[Docket No. FAA-2005-20700; Airspace Docket No. 04-AWA-8]

Establishment of Class C Airspace and Revocation of Class D Airspace, Orlando Sanford International Airport, FL; and Modification of the Orlando International Airport Class B Airspace Area, FL

Docket No. 04-AWA-8 ORLANDO, FLORIDA ESTABLISHMENT OF ORLANDO SANFORD INTERNATIONAL AIRPORT CLASS C AIRSPACE and

MODIFICATION OF ORLANDO INTERNATIONAL AIRPORT CLASS B AIRSPACE

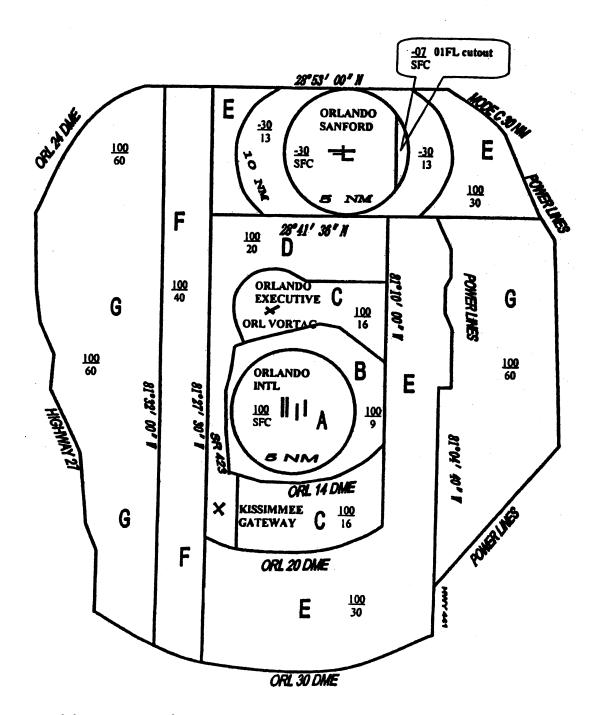
One commenter felt that changes to the MCO Class B to accommodate the proposed SFB Class C airspace might be unsafe. Concern was expressed that modification of the east-west visual flight rules (VFR) flyway between SFB and Orlando Executive Airport would compress traffic due to the locations of VFR practice areas and the Bithlo television towers.

A number of commenters, including the Aircraft Owners and Pilots Association (AOPA) cited the excellent safety record at SFB as evidence that Class C airspace is not needed at that location.

One commenter questioned the justification for Class C airspace at SFB based on the passenger enplanement count, stating the enplanement data alone do not tell the full story, and two commenters questioned the validity of Class C airspace at SFB because the SFB operations count has declined below the criteria threshold.

One pilot wrote that the proposed SFB Class C airspace configuration might be unsafe, citing the amount of restricted or otherwise controlled airspace already in the area (R–2910, MCO Class B, Daytona Beach Class C, etc.). The commenter objected to placing Class C airspace around SFB that would extend farther north than the current MCO Class B airspace boundary. This would crowd VFR aircraft into less space, particularly to the northwest of the proposed outer ring where two towers extend to over 1,700 feet MSL.

A majority of the commenters stated that the SFB Class C airspace would adversely impact, and place undue burdens on, VFR operations to, from, and transiting the terminal area. Several writers commented that they currently are able to operate to and from SFB without problems or delays. Several commenters felt that the existing MCO Class B airspace dominates the region and currently restricts VFR flying and that adding the SFB Class C airspace would make flying in the area more confusing. Commenters were also concerned that the implementation of Class C airspace might cause congestion and bottlenecks on approach control frequencies and otherwise result in limitations on general aviation access to the airspace.

A suggestion was made that the floor of the SFB Class C airspace in the 5–10 mile ring be raised from 1,300 feet MSL to 1,600 feet MSL to allow transiting VFR aircraft to fly beneath the area at 1,500 feet MSL.

One commenter suggested that a north-south VFR flyway be established directly over SFB.

FAA Response: The FAA does not agree. The modification of the MCO Class B airspace area to accommodate the SFB Class C airspace will not adversely impact operations to or from MCO. In addition, raising the floor of Class B airspace from 1,600 feet MSL to 2,000 feet MSL around Orlando Executive Airport will provide additional airspace for VFR aircraft to utilize while remaining below the floor of the MCO Class B airspace. The eastwest flyway will be moved only one or two miles south of its current location and will remain north of the Bithlo towers and north of the Lake Apopka practice area. The modifications will provide additional flyway and transition airspace for VFR aircraft as compared to the present airspace configuration.

FAA Response: The commenter is incorrect regarding the extent of the SFB 10-NM ring. The original configuration of the proposed SFB Class C airspace did include a full 10-NM ring north of the airport. However, based on feedback from the ad hoc committee meetings, and as described in the NPRM, the proposed SFB Class C airspace design was changed so that the 10-NM ring was eliminated north of the current northern boundary of the MCO Class B airspace area along latitude 28°53'00" N. Therefore, Class C airspace will not extend into the airspace in question near the towers nor will the SFB Class C airspace result in additional crowding of VFR aircraft between the Daytona Beach Class C airspace area and the current northern edge of the MCO Class B airspace area. Similarly, to the south of SFB, the Class C 10-NM ring was

FAA Response: The FAA does not agree. Current traffic routings and proposed Class C routings were compared and it was found that the new Class C airspace would have minimal negative impact on users. Procedures for the Class C airspace operation will allow SFB users to continue flying much as they do today. The FÅA believes that this rule will provide an additional level of safety for VFR aircraft operating at SFB and in the Orlando terminal area. A minimal increase in flying miles (five miles further west or east of SFB) may be required for pilots desiring to transit outside the SFB Class C and MCO Class B airspace areas. With Class C airspace, all VFR aircraft flying to SFB will receive radar service. ATC will utilize three arrival sectors for handling inbound aircraft. This will result in less difficulty arriving at SFB and may reduce flying time to enter the traffic pattern. The modifications to the MCO Class B airspace will also provide additional airspace for VFR aircraft in the area to the north of Orlando Executive Airport and south of the SFB Class C airspace area. A new northsouth VFR flyway is being added to the east of the SFB Class C airspace area. The FAA is also establishing two new VFR waypoints (VPAPO southwest of SFB at lat. 28°40'15" N., long. 81°31'31" W.; and VPBIT southeast of SFB at lat. 28°39'54" N., long. 81°01'18" W.). The new waypoints will assist VFR navigation through the expanded eastwest VFR flyway that lies between Orlando Executive Airport and SFB, and the north-south flyways to the east and west of the SFB Class C airspace area. The FAA will allow SFB VFR

FAA Response: The FAA does not agree with the suggestion. The crossing altitudes at the final approach fixes are 1,500 feet MSL and 1,600 feet MSL. Raising the floor as suggested would result in conflicts that the Class C airspace is designed to eliminate.

FAA Response: The FAA does not agree. Currently, aircraft transitioning over SFB at 1,500 feet MSL, as approved by SFB Tower, total only about five per day. With the implementation of the SFB Class C airspace area, a transition over SFB at 2,500 feet MSL would be possible for aircraft in contact with MCO approach control. A VFR flyway directly over SFB would not be feasible. VFR flyways provide general flight paths for pilots planning flights into, out of, through, or near complex terminal airspace so as to avoid Class B airspace. Flyway altitudes must avoid airspace that requires prior authorization or clearance to enter. A flyway over SFB would result in departures being restricted below the flyway altitude until clear of the flyway. The airspace between 2,000 feet MSL and 3,000 feet MSL over SFB is used to transition arrivals and departures to/from Orlando Executive Airport. Due to the complexity of the airspace in the SFB area, the suggested flyway is not feasible because it would impact SFB operations, and/or require pilots to

This action amends Title 14 Code of Federal Aviation Regulations (14 CFR) part 71 to modify the MCO Class B airspace area, establish the SFB Class C airspace area, and revoke the SFB Class D airspace area. The specifics of this action (depicted on the attached chart) are summarized in the following paragraphs. In addition, this rule revokes the Class E airspace extension to the SFB Class D airspace area.
